SUPPLEMENTAL REPORT
REVIEW OF COMPLIANCE PROGRAM
MT. LAUREL II OBLIGATION
LAWRENCE TOWNSHIP, NEW JERSEY

Honorable Eugene D. Serpentelli, J.S.C.
Ocean County Court House
Toms River, New Jersey 08753

March 28, 1985

Carl G. Lindbloom, P.P.
Princeton, New Jersey

(as presently proposed)

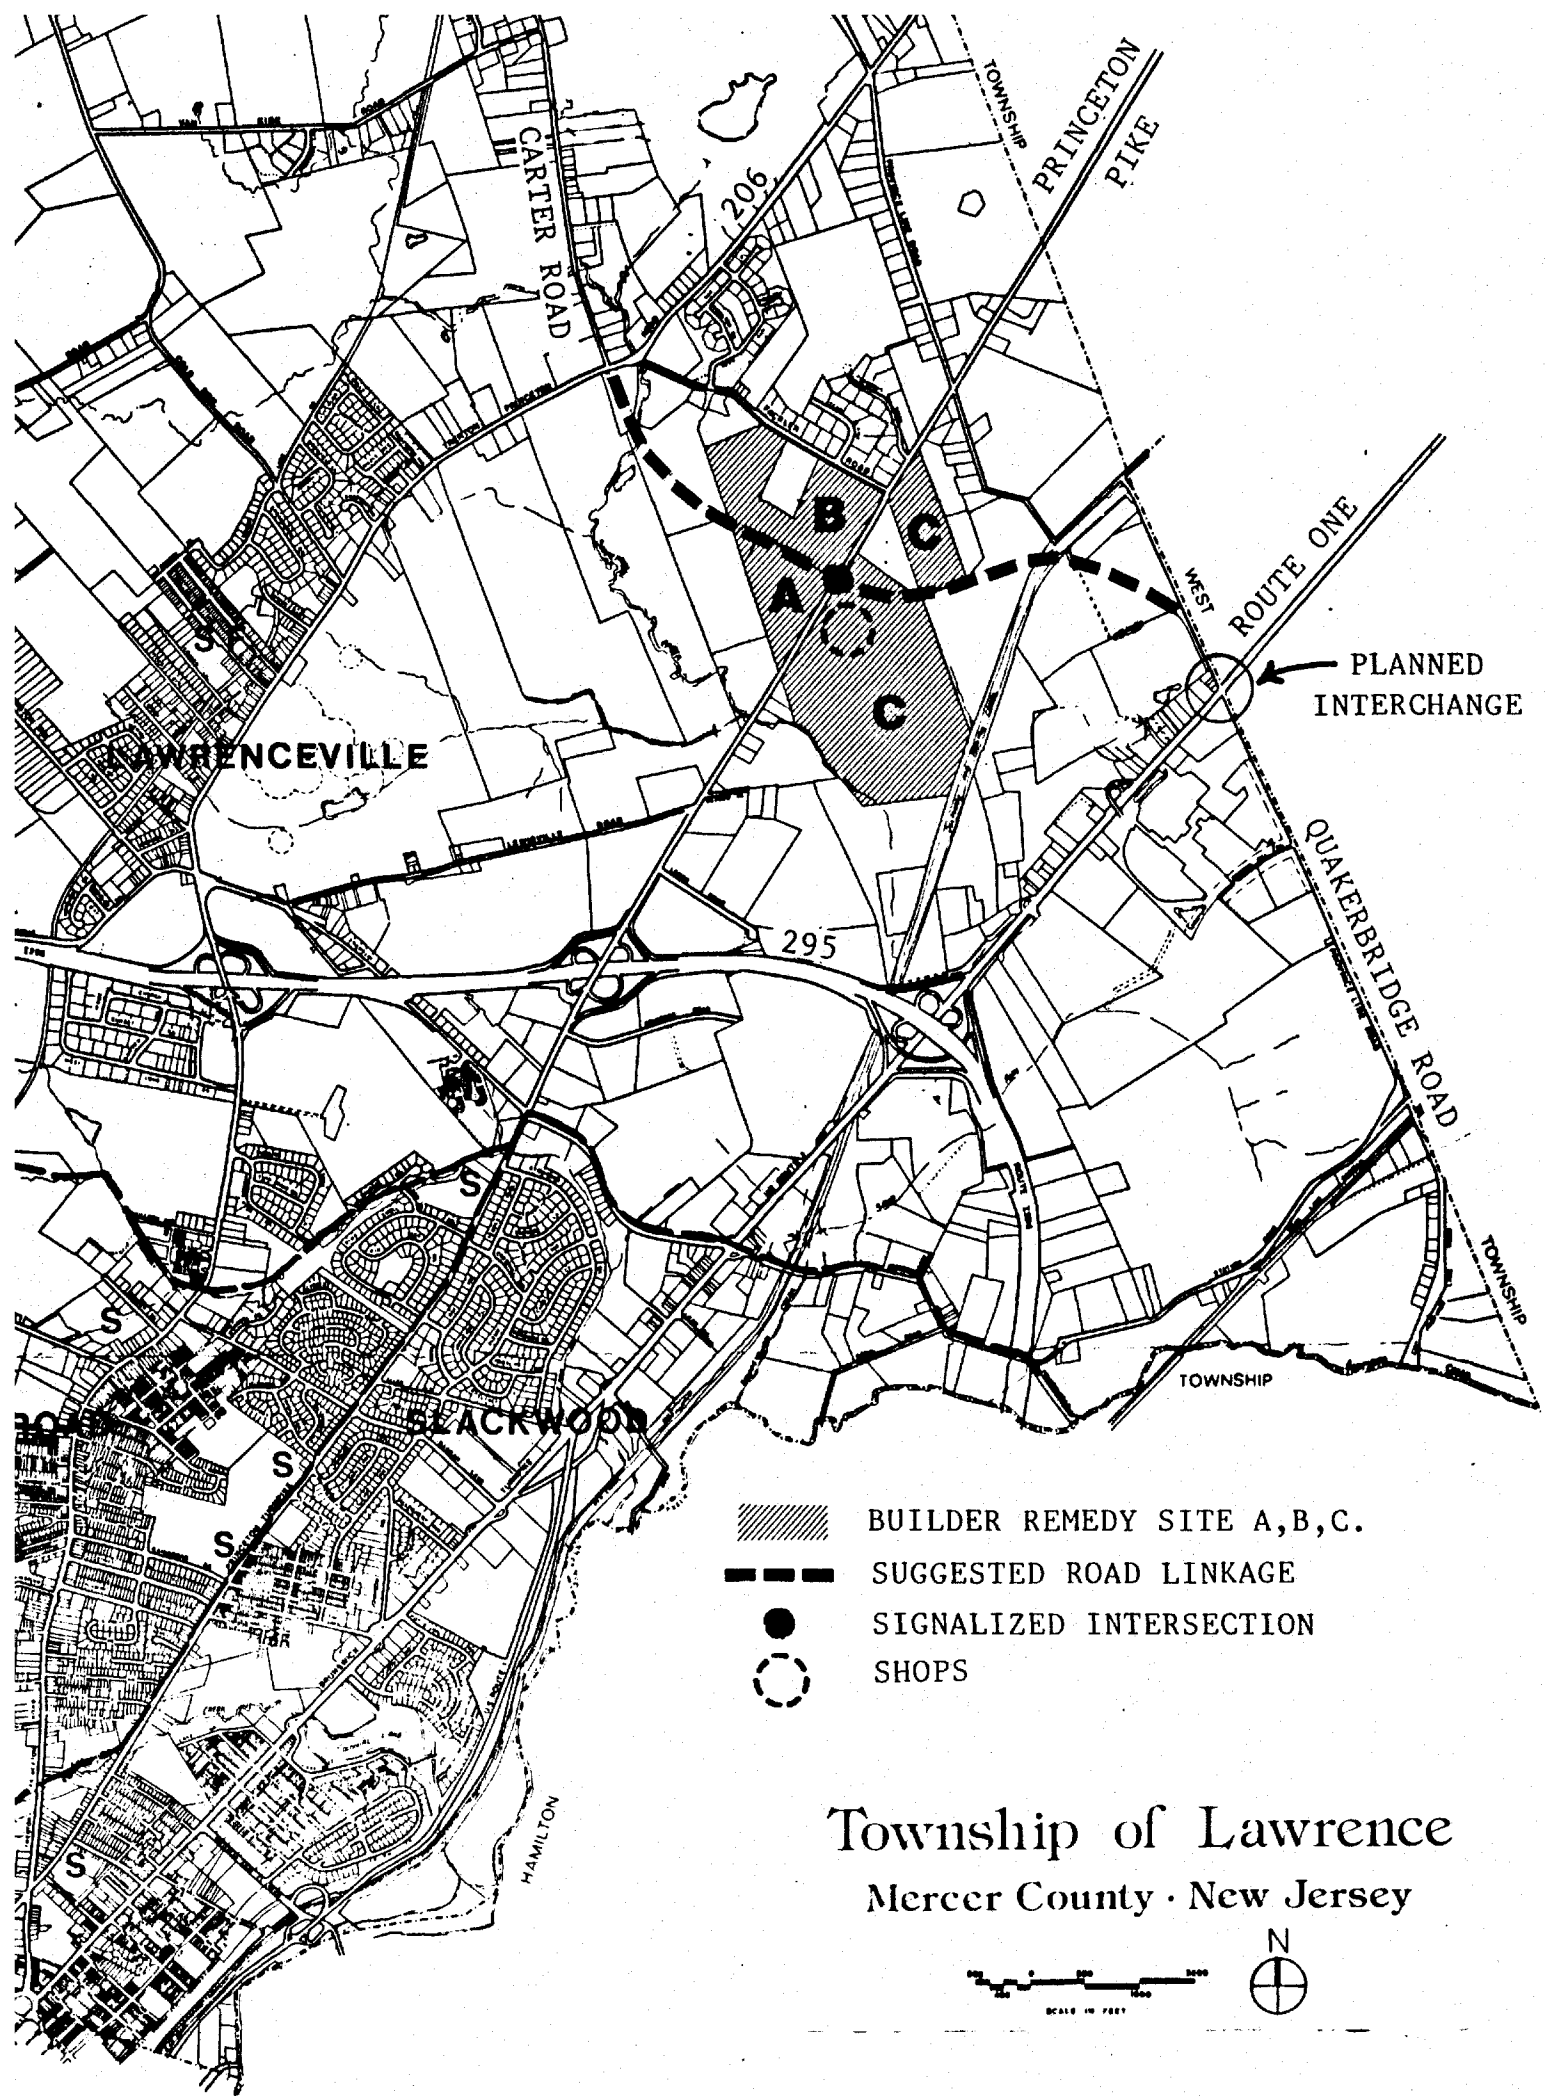
The combined tract has access only (at present) to Princeton Pike, access to Mercer Mall and Lawrenceville (nearest shops) is poor; there are no existing buffers to adjacent low-density residential use areas; there are no community facilities provided; and much of parcel C has serious environmental constraints forcing an unacceptably high net density for this area. The proposal (combined) to construct almost 2,000 multi-family units, of which 400 would be set aside for low- and moderate- income housing, in a location with such limitations and deficiencies cannot be considered sound planning. In fact, to accept development of this combined tract, as proposed, would be the antithesis of sound planning.

Although the combined site, as presently proposed, represents unsound planning, the opportunity does exist to correct many of the existing site deficiencies. Such correction, however, would require the cooperation of the three developers and the Township. The attached sketch illustrates the changes necessary to make this level of development acceptable at this location. They include;

Access. A road linkage from Princeton Pike to Quakerbridge Road (an extension of the Quakerbridge Road realignment proposed for Port Mercer Village) would provide direct access to Route One, shopping and community facilities. This linkage would be largely within the development site and would greatly improve access. It could also be later extended to Route 206 at Carter Road, as proposed on the Township Traffic Circulation Plan, further improving site access and area circulation.
